PLAN COMMISSION MEETING AGENDA

TUESDAY, November 26, 2013
AT 6:00 P.M.

Plan Commission Report

PROJECT: Plan Review – Peter Caruso, Black Bear Bottling Group

EXTERIOR ELEVATIONS

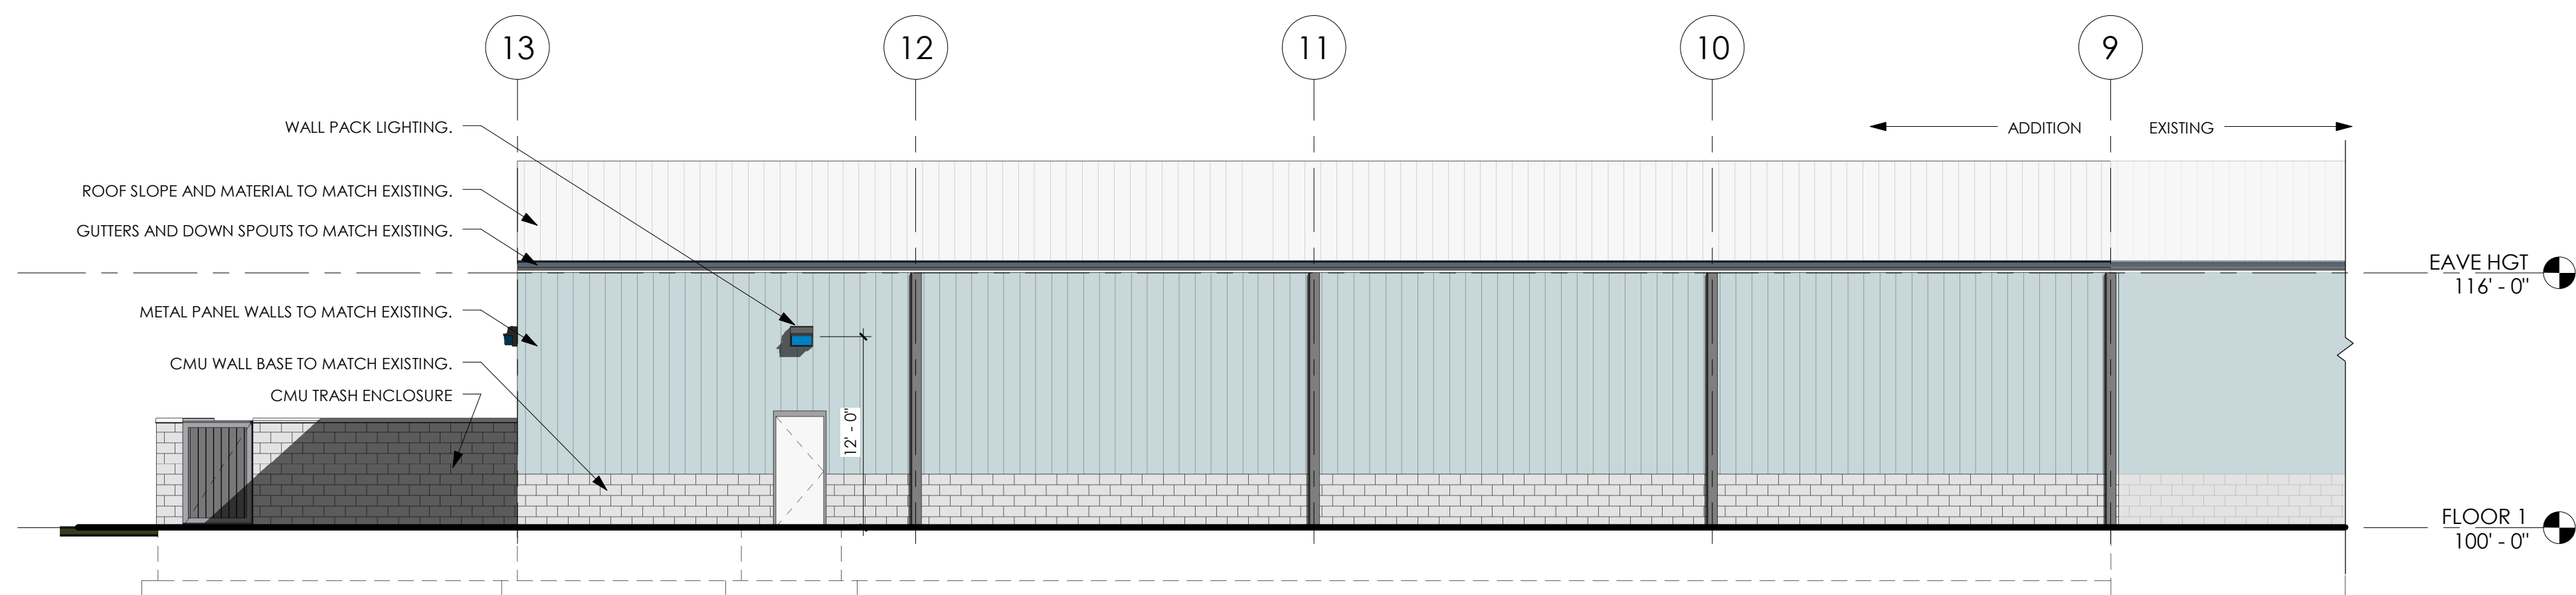
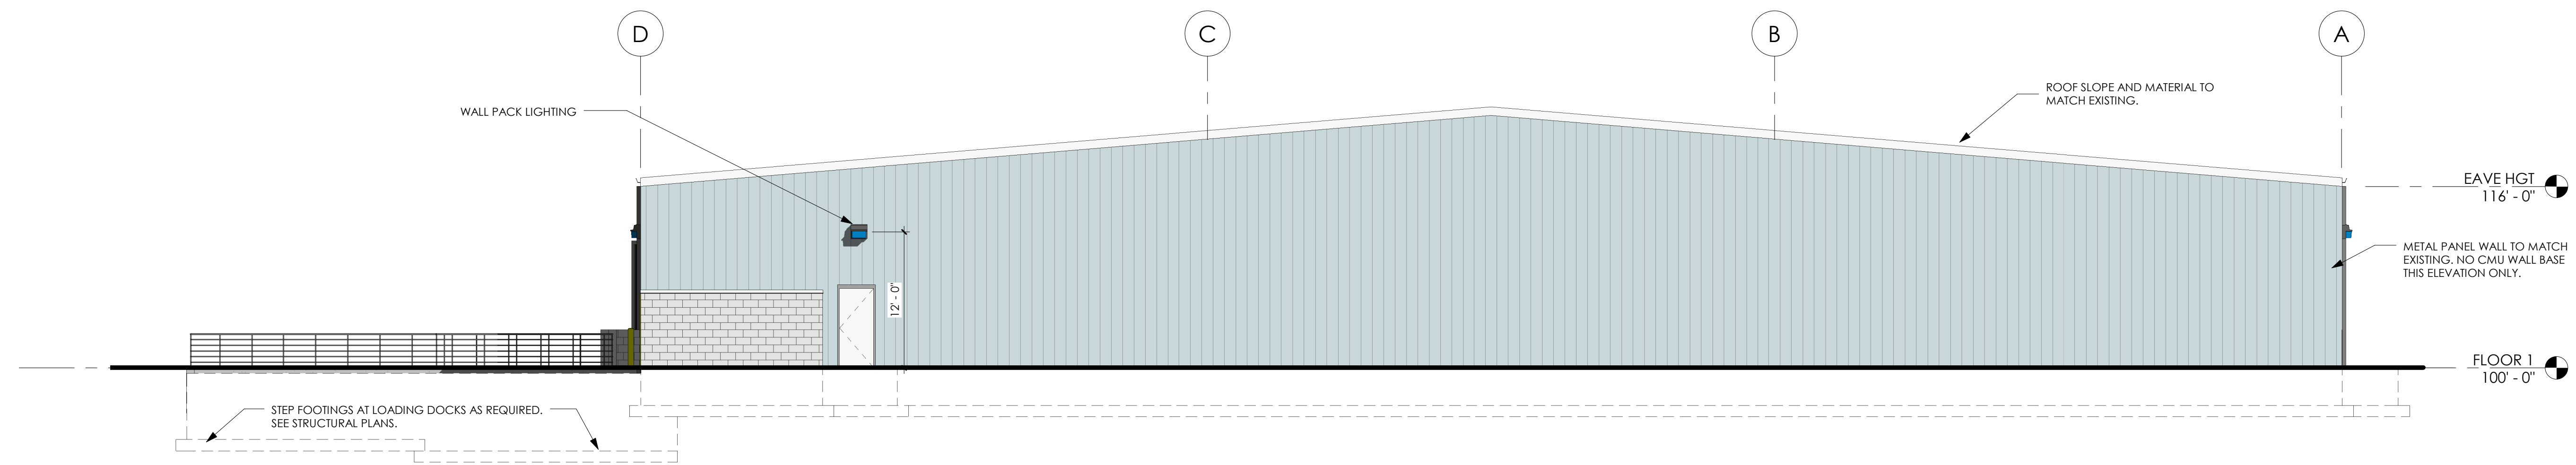
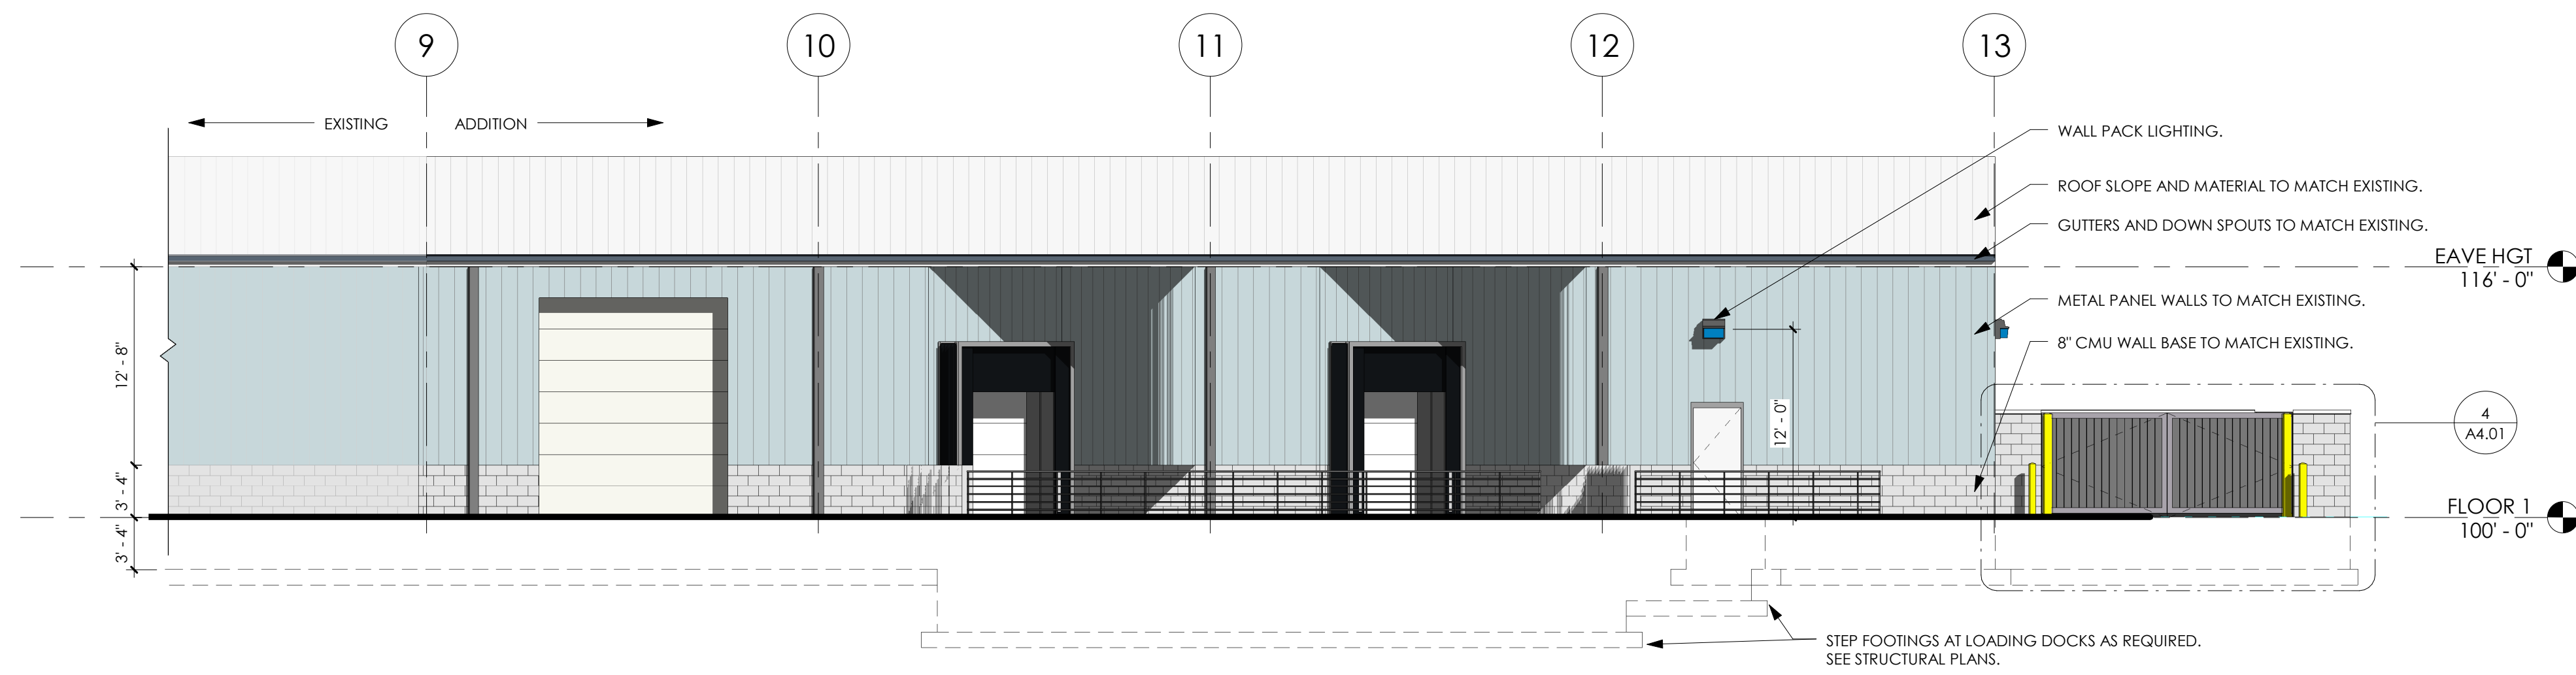
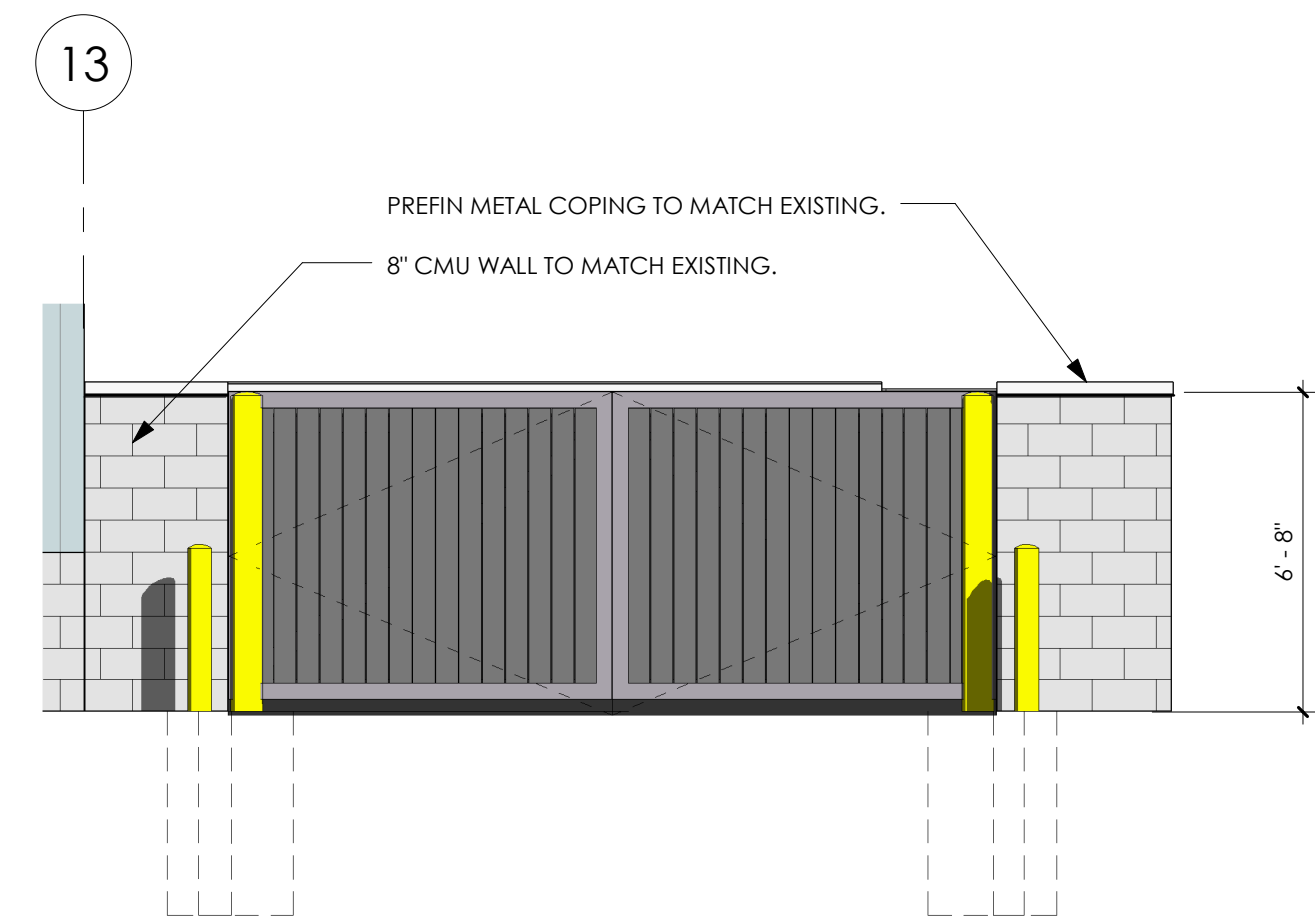
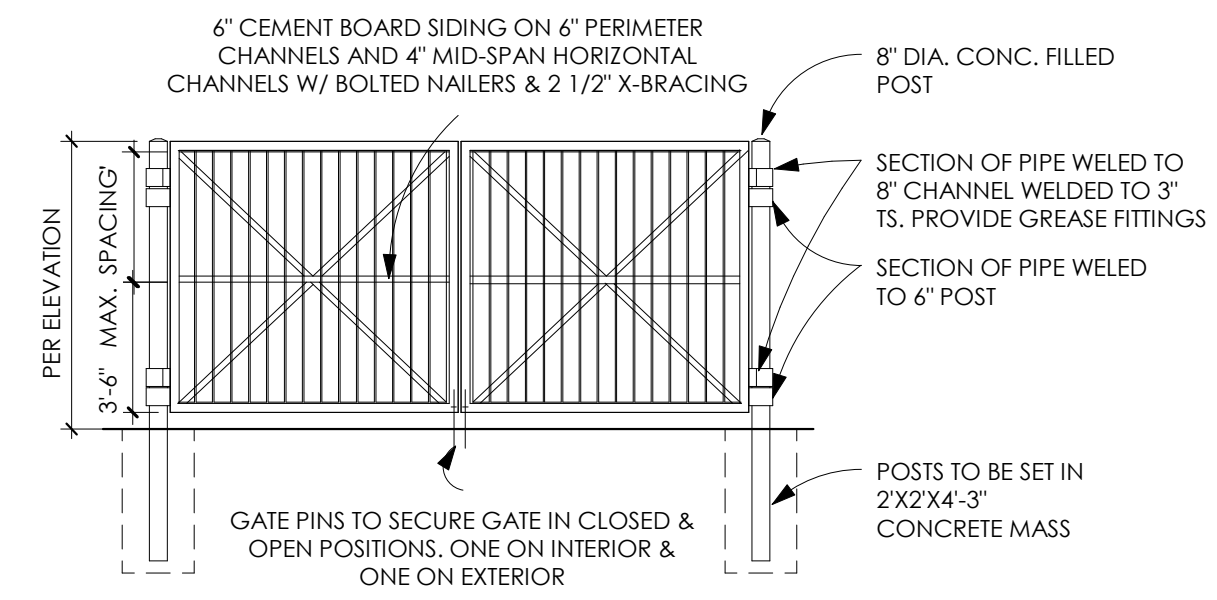
A majority of the proposed addition will be constructed using pre-finished corrugated steel panels over a 4-foot (height) concrete block base (20th Street and east sides only) to match the existing building. As such,

the materials require a $\frac{3}{4}$ majority approval of the Plan Commission. Colors will also match the existing building.
